Memorandum

From: Lucy Sloman, DSD Land Development Manager
Dan Ervin, DSD Engineering Consultant
Mike Martin, DSD Associate Planner

Subject: Preliminary Plat – Talus Parcels 7-9
File No: PP14-00001

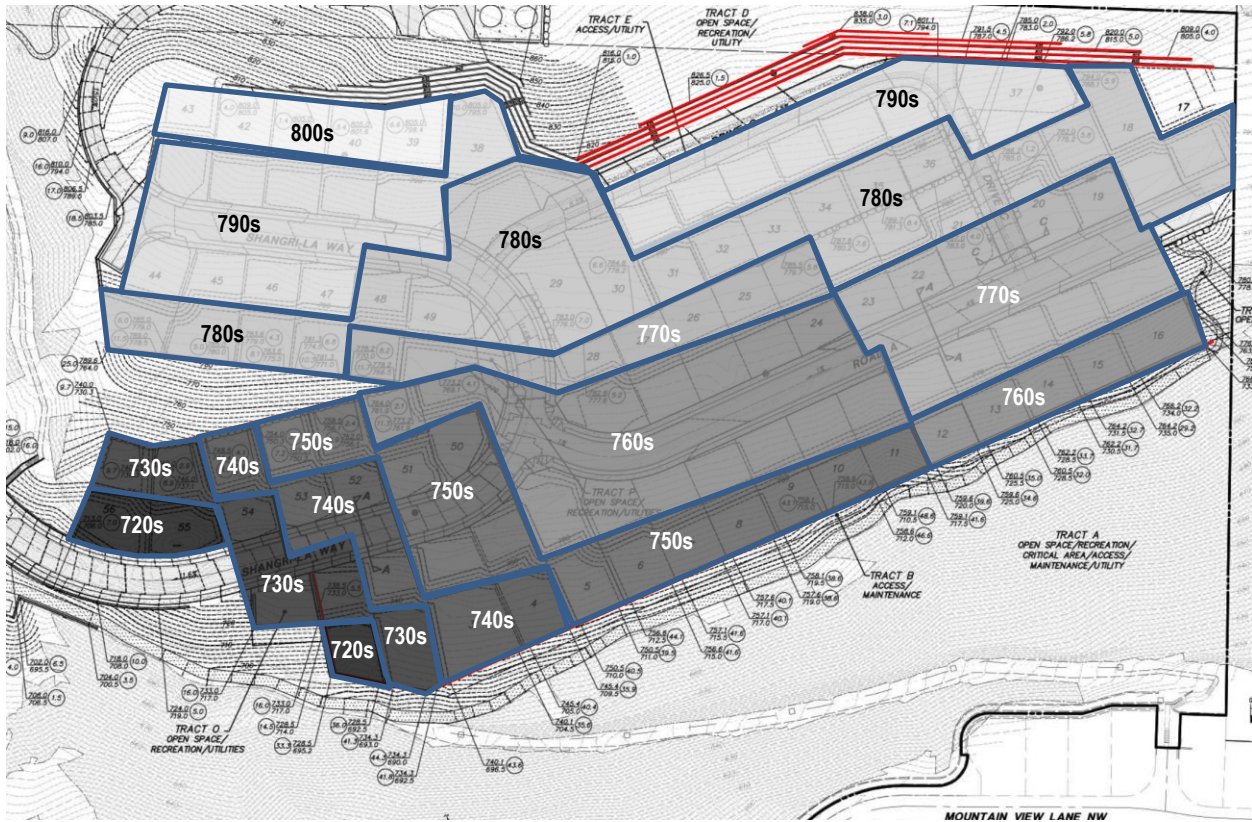
The site doesn't respond to the topography, the walls are too tall, this is inconsistent with the Development Agreement.

Staff: The walls have been discussed extensively in the Staff Report and the previous Briefing Response Memo. (See Attachment 1 to this second memo with excerpts regarding walls from the Staff Report and first Briefing Response Memo.) Staff continues to support that the proposed walls are consistent with the Development Agreement. To assist in understanding how Parcel 7 proposes to respond to the topography, Staff have prepared the following graphics.

The above schematic section illustrates how the lots in Parcel 7 step up the hill approximately 30 ft from the eastern wall to Drive C. [The 'cut' was made at approximately Lot 11 to Lot 33 – see section line below; 'el' = elevation.] Note the dimension of the eastern wall is from the original submittal, not as modified by the Applicant's current proposal.

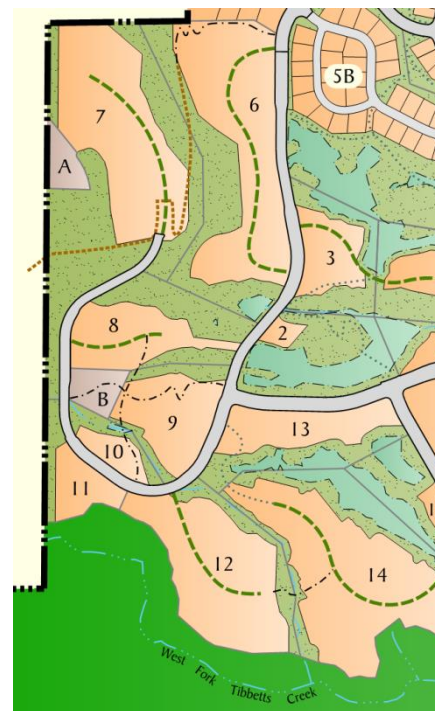
With regards to the plat: The roads are too narrow for emergency access or school buses. The dead-end roads also impact emergency access since they can't turnaround. And dead-end roads aren't consistent with the project. There isn't proper connection to the main road.

Staff: *One road in and out of Talus:* It is true that most of the time, Talus functions with one road in and out of the project, i.e. Talus Drive. The project was designed with awareness that due to the topography along SR 900 it was tricky to access the developable property west of SR900. Eastside Fire and Rescue (EF&R), Public Works Engineering, Issaquah Police Department, and others reviewed the overall plans with regards to this and other issues at the time the Development Agreement was adopted. This configuration was approved by all the reviewers. In the

Road design and emergency access, school bus access: All the roads at Talus are designed and constructed to comply with adopted road standards. EF&R also reviewed the road standards during adoption of the Development Agreement. Included in the road standards are Fire Turnarounds which are required with a deadend road. Each deadend road in this plat includes a standard Fire Turnaround. They may not be apparent as we attempt to integrate them into the overall design in such a way that they don't stick out. With regards to school bus access: again the roads meet the adopted codes. The school district does not intend to access every road in a residential area. Each year they review and revise bus routes, and work with the City to establish appropriate routes for their needs.

Deadends roads: Deadend roads are generally avoided in urban villages; however, there are circumstances where it is difficult to not use them, such as at the Project edges and with steeper topography. This plat illustrates examples where it is difficult to completely avoid their use.

Connection to main road: The original plan included with the adoption of the Development Agreement showed schematically how all parcels would get road access. As you can see in the excerpt of this schematic map (right), the plat's proposed road access to Parcels 7, 8, and 9 is similar to that of the original schematic plan including the connection to Talus Drive (just north of Parcel 13).

Parcel 7's terraced walls

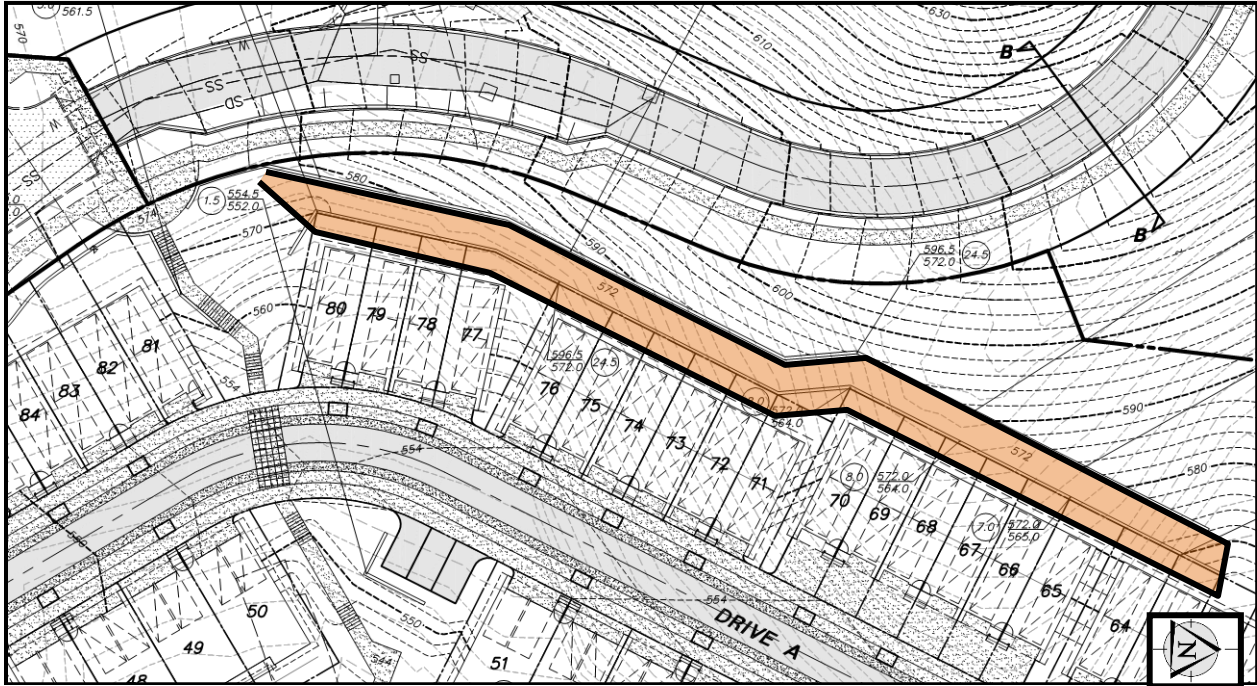
- Multiple, terraced low retaining walls should be used, and the proposed plat utilizes terraced walls in some areas such as the west side of Parcels 7 and 9.
- Low (4-10 ft), single walls are proposed in other areas such as the middle of Parcel 9 as well as the southern edge of the parcel, along Shangri-La Way; the southern edge of Parcel 8; and in the middle of Parcel 7.
- Tall walls are used frequently through this plat, for instance: 15-20 ft on the east and west sides of Parcel 9, paralleling Shangri-La Way; 10-25 ft along the north side of the Parcel 8 road and the west side of Shangri-La Way between Parcels 8 and 9; 10-25 ft along the south edge of Parcel 7 as well as 10-50 ft along the east side of Parcel 7.

In some cases these walls are tall but not located where people will be near them, i.e. they separate lots above the wall from natural open spaces areas below them. However in other cases the walls, especially the very tall ones, will be in close proximity to pedestrians, e.g. the trail along the bottom of the Parcel 7 east wall. The guidelines for walls say “When practical, terrace retaining walls to reduce bulk and to create planting areas.” Thus terraced walls shall be designed and spaced so that plantings, including trees, can be placed between them in order to provide visual relief, integrate them into the site, and reduce their visual bulk. **(Condition 7)**

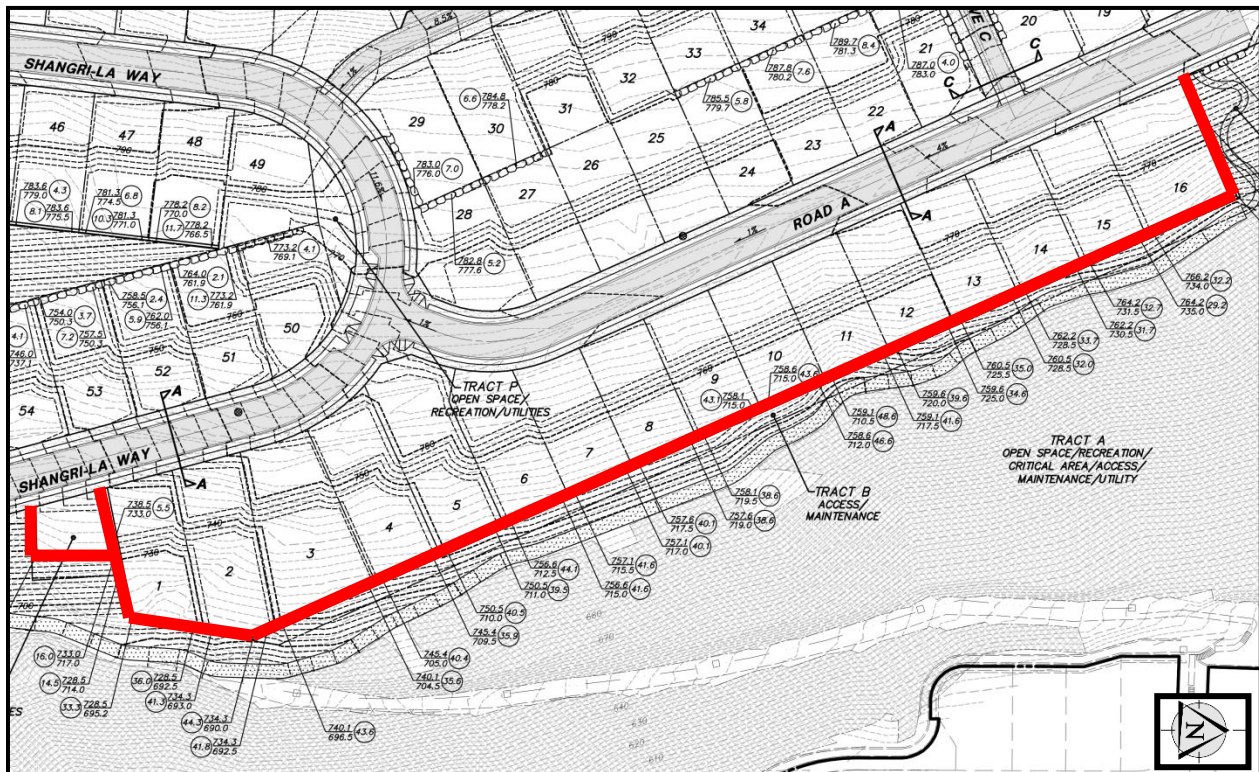
However, in some circumstances, the reason the wall is so tall is that it's chasing the slope, and terracing wouldn't reduce the wall height, you would just have a series of very tall walls. The only way to reduce the height would be to separate the parcel into more than one building pad, which would be less efficient for lot layouts, but might reduce wall heights. That does not seem practical. The guidelines also say walls need to add visual interest to the neighborhood and where large and/or tall walls are present, articulate large expanses of walls to provide visual relief and reduce visual bulk and size. In addition, where large walls are used, landscape plantings and/or artwork are employed to soften the visual effect. Thus all the walls need to be designed in ways that make them visual interesting, the larger ones are articulated, landscape material is added to provide scale when a pedestrian is nearby. A trail is proposed at the base of the wall in Parcel 7. Landscaping should be provided between the wall and the trail in order to create pleasant environment and to reduce the presence of the wall for trail users.

(Condition 8).

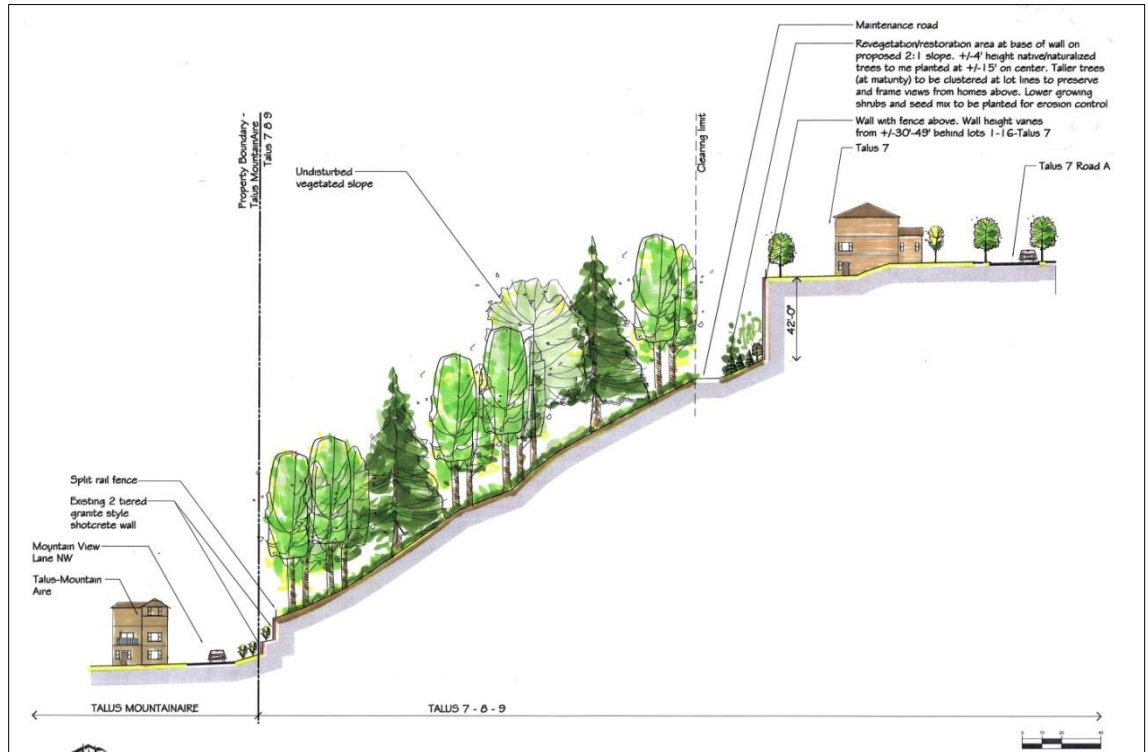
Tall and long walls do not seem in line with the Talus Goals or Guidelines.

The Mountain Village character of development results in parcels which are separated by open space areas. In a mountainous terrain this will require the use of walls to preserve open space areas while making efficient use of the land. "4.0 General Community Goals, Goal 1 excerpts; The Urban Village is defined by.. discernible edges, efficient utilization of land and accessible open space..." "Talus will be an urban village adapted to reflect the mountainous terrain of the site. The result will be an urban village with a mountain village character. Generally this means development that conforms to the topography of Cougar

The clustering of development in parcels separated by open space areas distinguishes Talus from other Master Planned Communities in the area. Achieving urban densities without mass grading the majority of the site is a challenging aspect of developing to meet the Mountain Village character. As a result walls are a necessary component to achieve the density goals while preserving large areas of open space. But having open space in proximity to the development parcels is a key reflection of Goal 4: Preserve and protect the natural environment within East Village. Excerpts from Goal 4: “The natural environment is one of Talus’ greatest assets. Finding the balance between the preservation of natural open space and the development of a livable, self-sufficient community is a challenge. This challenge has been met at Talus by dedicating approximately 73 percent of the land as open space including an approximately 388 acre Native Growth Protection Area (NGPA) south of West Fort Tibbetts Creek and approximately 71 acres of open space generally located between development parcels.”
